RESPONSES TO NRC QUESTIONS ON  
THE ROCS-DIT TOPICAL

CENPD-266

AMENDMENT 1-NP

February 1983

FIGURE 1  
 SENSITIVITY OF  $k_{\infty}$  vs ASSEMBLY GROUP STRUCTURE  
 16 x 16 ASSEMBLY WITH 16  $Gd_2O_3/UO_2$  SHIMS AT 2 Wt%  $Gd$  LOADING

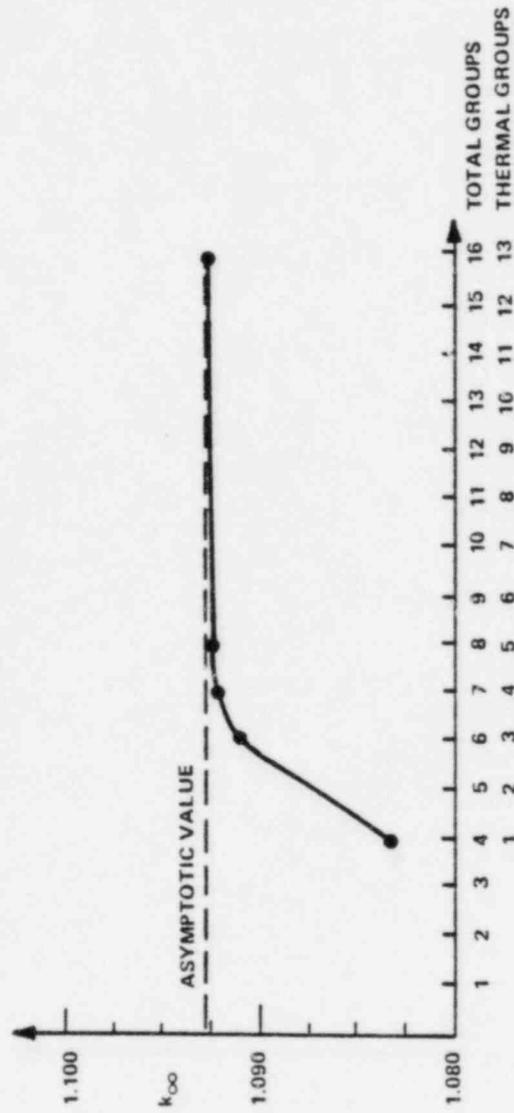
The modeling of gadolinia in DIT makes use of existing capabilities in the code which enable detailed calculation of the flux and spectrum in the gadolinia pins and surrounding assembly. These include use of heterogeneous geometry for both spectrum and assembly calculations, increased radial subdivisions for gadolinia pins, azimuthal flux variation in the vicinity of Gd and waterholes, and use of an appropriate broad energy group structure for the assembly calculation (See Figure 1 attached).
